Access Compliance Report

Public Rights-of-Way

(Curb Ramps)

Intersection ID: 10025478	Main Street: E_JOHN_BELK_RA	Cross Street: E_STONEWALL_ST	Location: NE
ADA ID: 98BB7A441CE8	Ramp Type: PerpDiag	Initial Pass/Fail: Fail	Overall Compliance: No
		Severity Score: 8.75

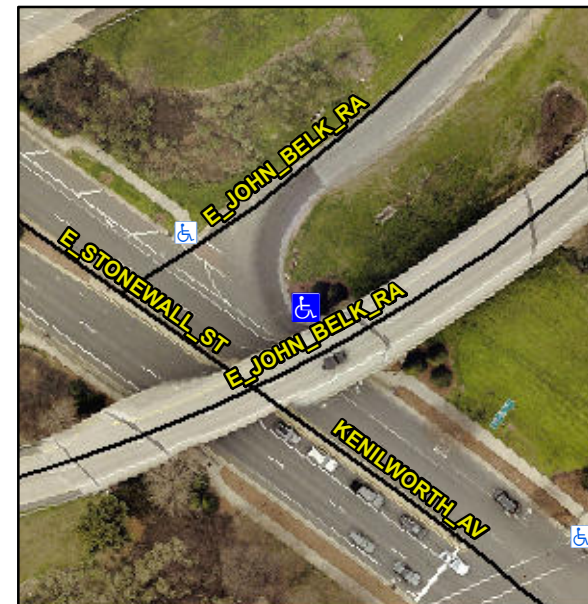
R304.5.1

Compliance	Description	Data	Compliance	Description	Data
N/A	Ramp Length (in)	67.0	Yes	Ramp Slope (%)	6.6
No	Ramp Width (in)	47.0	Yes	Ramp XSlope (%)	1.2
N/A	Flare Type LT	N/A	N/A	Flare Type RT	N/A
N/A	Flare Slope LT (%)	N/A	N/A	Flare Slope RT (%)	N/A
N/A	Flare Traversable LT?	N/A	N/A	Flare Traversable RT?	N/A
N/A	Landing Length (in)	N/A	N/A	DWS Provided?	N/A
N/A	Landing Width (in)	N/A	N/A	DWS Contrast?	N/A
N/A	Landing Slope (%)	N/A	N/A	DWS Length (in)	N/A
N/A	Landing X Slope (%)	N/A	N/A	DWS Full Width?	N/A
N/A	Landing Curb? (Y/N)	N/A	N/A	DWS Offset (in)	N/A
N/A	Shared Landing?	N/A			
N/A	Gutter Ponding?	N/A	N/A	Gutter Slope (%)	N/A
N/A	Gutter Lip Ht (in)	N/A	N/A	Gutter X Slope (%)	N/A
N/A	Painted X Walk1?	Yes	N/A	Painted X Walk2?	No
	X Walk 1 Direction	To NW		X Walk 2 Direction	To SW
N/A	X Walk 1 Width (in)	96.0	N/A	X Walk 2 Width (in)	N/A
	X Walk 1 Slope (%)	2.9		X Walk 2 Slope (%)	1.2
	X Walk 1 X Slope (%)	0.2		X Walk 2 X Slope (%)	1.7

Remove & Replace Curb Ramp With Two New Directional Ramps or Equivalent.
